Please find hereafter a summary of all comments of the two referees. Page and line numbers refer to the revised marked-up manuscript.

Responses to anonymous Referee #1, 02 Jun 2018

Improvements ~~to~~ the hydrological processes of the Town Energy Balance Model (TEB-Veg, SURFEX v7.3) for urban modelling and impact assessment

Figure 1: SchemaDiagram of the hydrological processes involved in the TEB-Hydro model; subscripts *rf* and *bld* stand for building compartment, *rd* for road compartment, and *gdn* for garden compartment

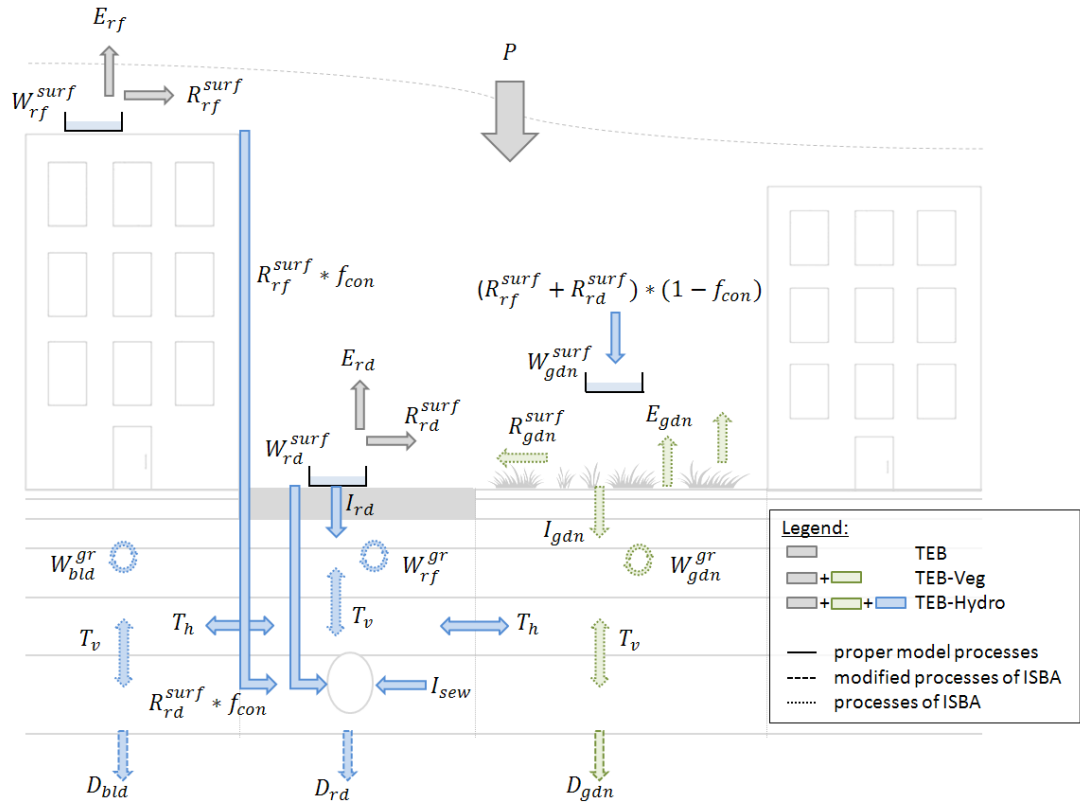
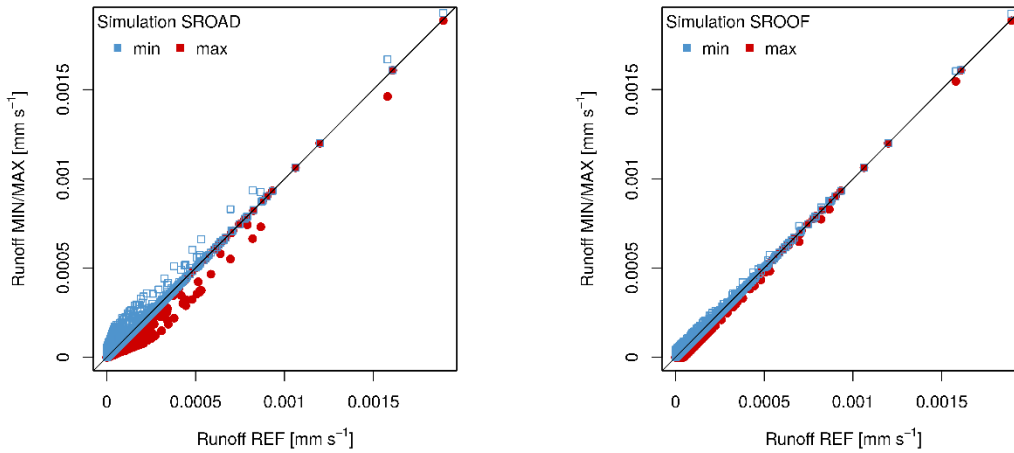
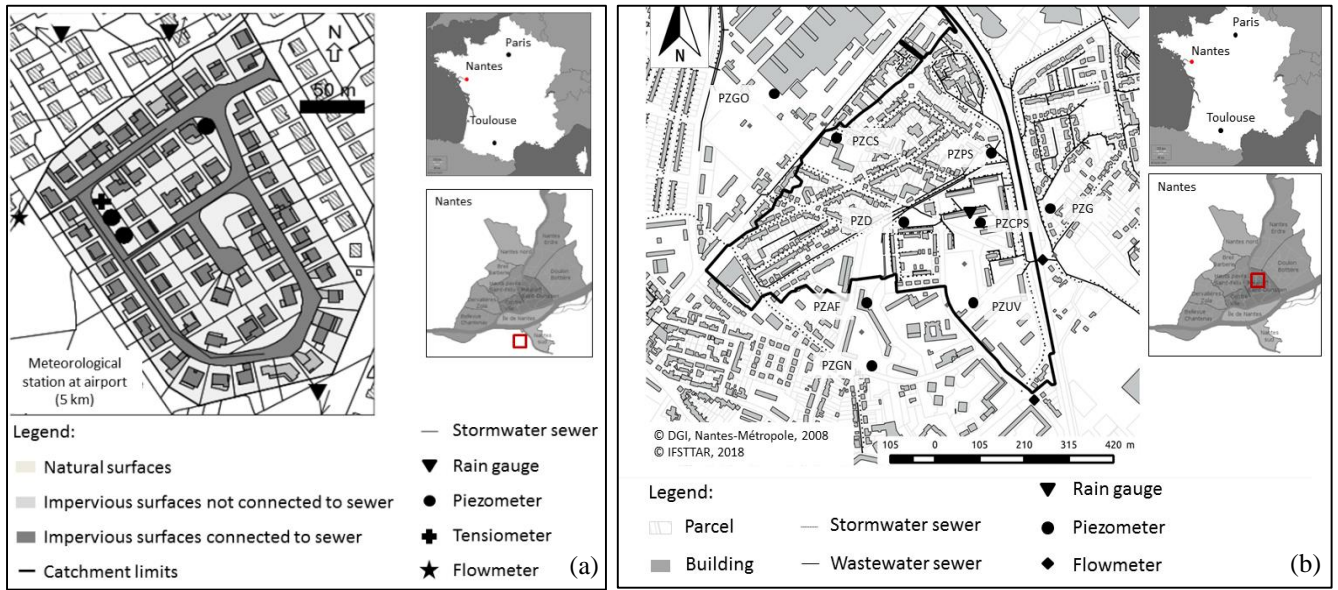
P6L3: A useful description would be to add a section or table describing how/if these parameters were considered in previous version of the TEB and specifically to additions with the TEB-veg model.

ACs: You are right; we referred to Fig.1 in this section.

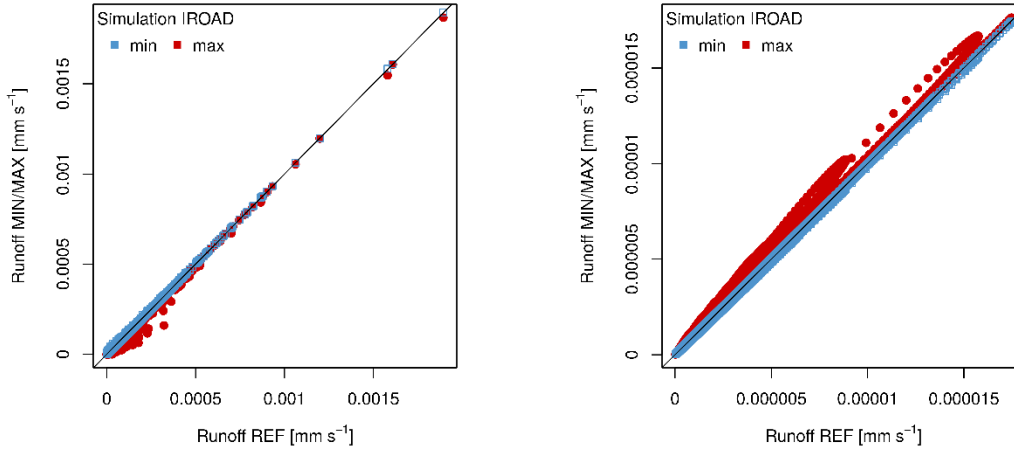
A minor point but the number notation changes on the x-axis in a number of Figures - e.g. 4 and 7.

ACs: The figures have been changed. Please refer to the supplement document.
